Request for Quotation

RFQ NUMBER
LOT471

ADDENDUM #2

**WV LOTTERY HEADQUARTERS
RENOVATIONS & ADDITIONS**

ADDENDUM NO. 2	SKETCH NO. SKP1
SCALE: NTS	SHEET NO.
DATE: 03/09/11	P3-8
DRWN: KAS

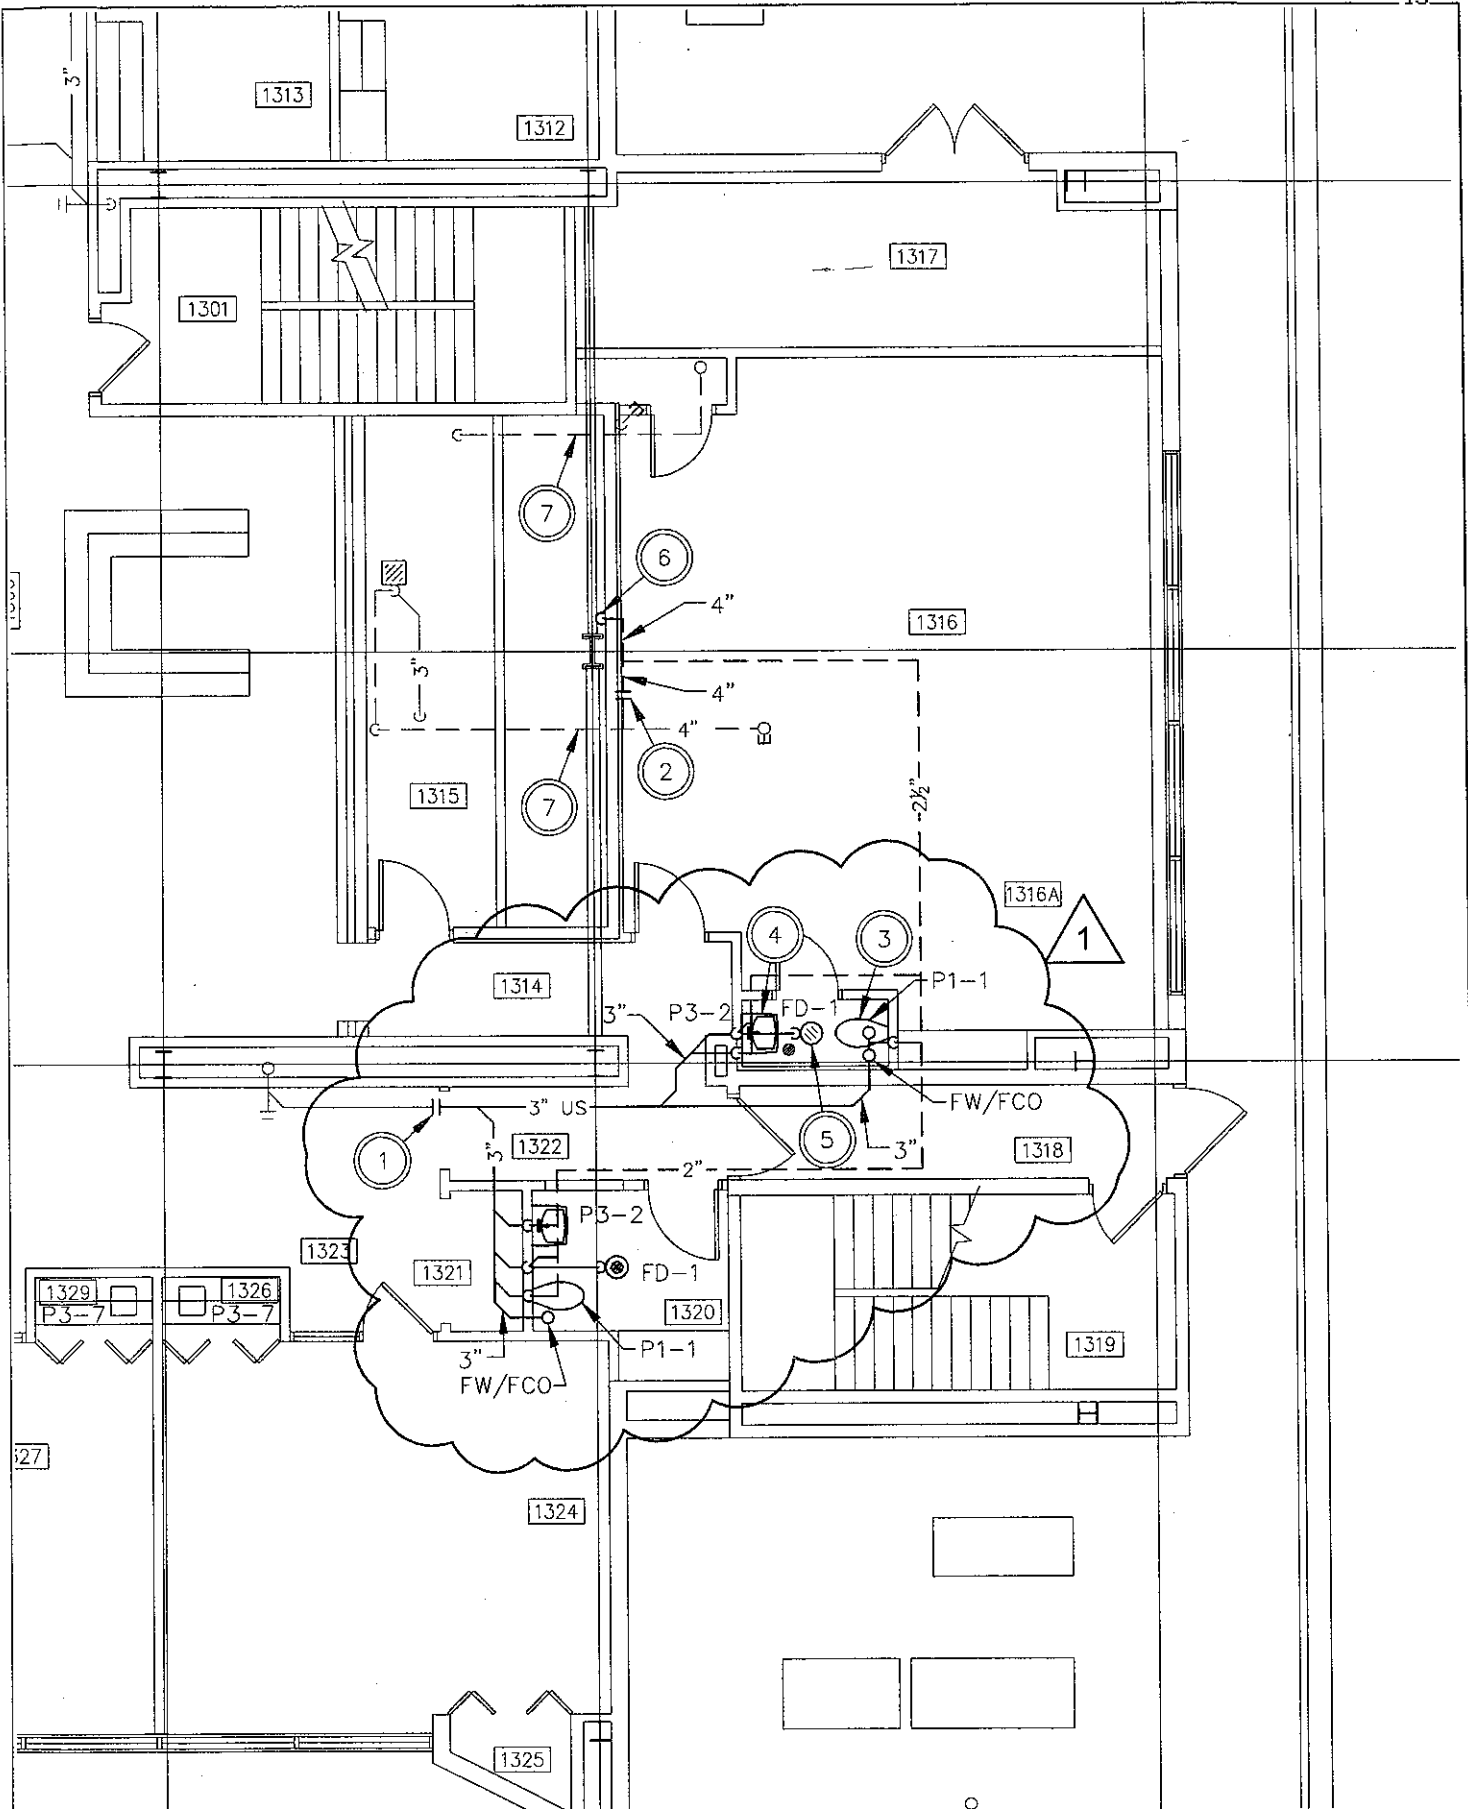
Item 3: Drawing P3-8:

a. Revise DCW pipe sizes, see attached sketch SKP1.

SKETCH NO.
SKP2
SHEET NO.
P3-11

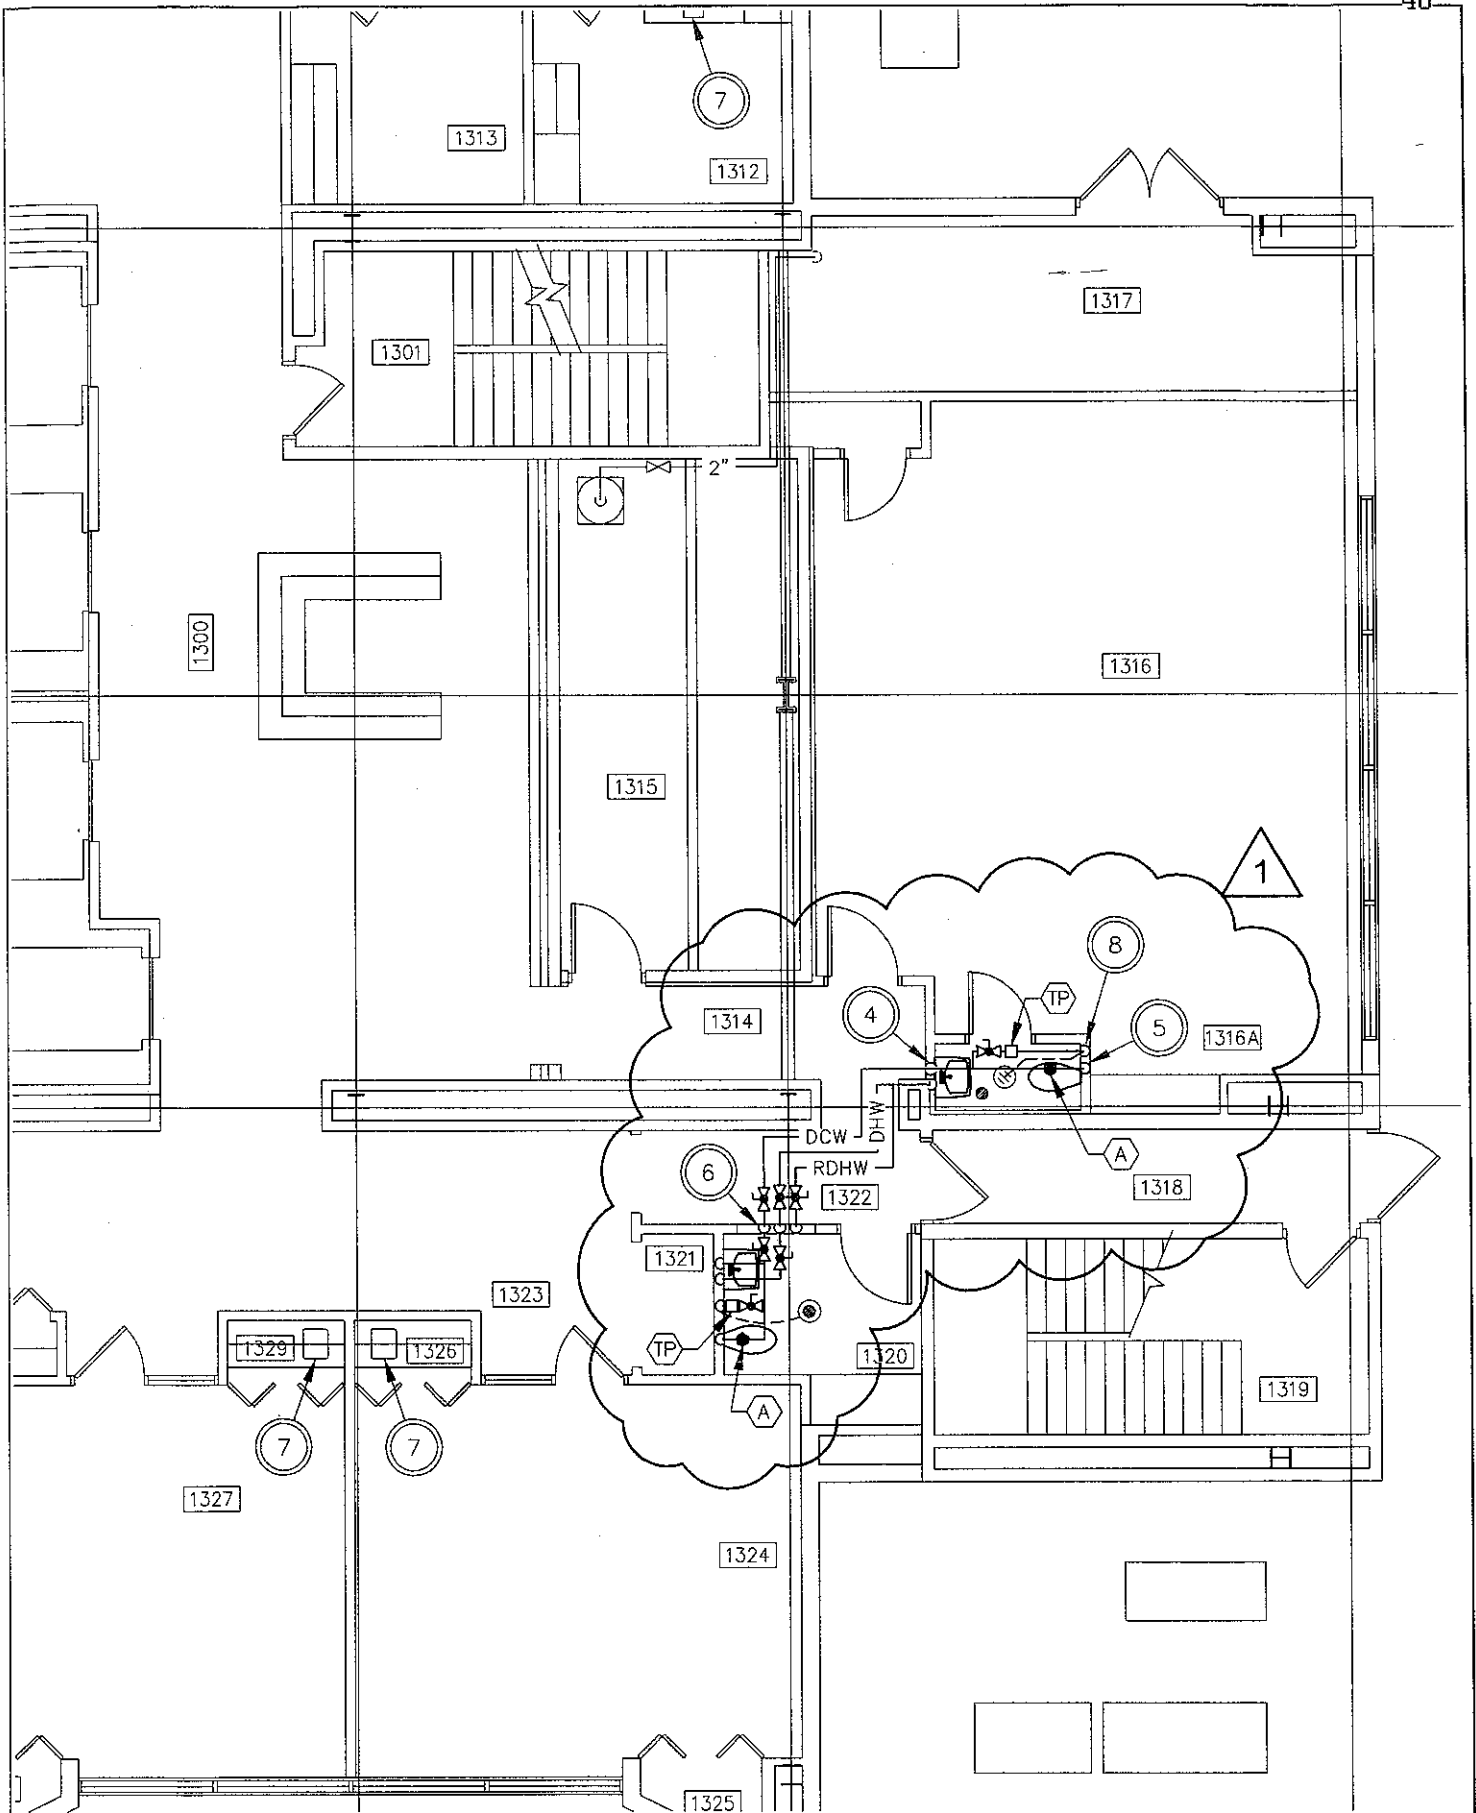
Item 4: Drawing P3-11:

a. Added water closet, lav, and floor drain and associated waste piping in Room 1320, see attached sketch SKP2.
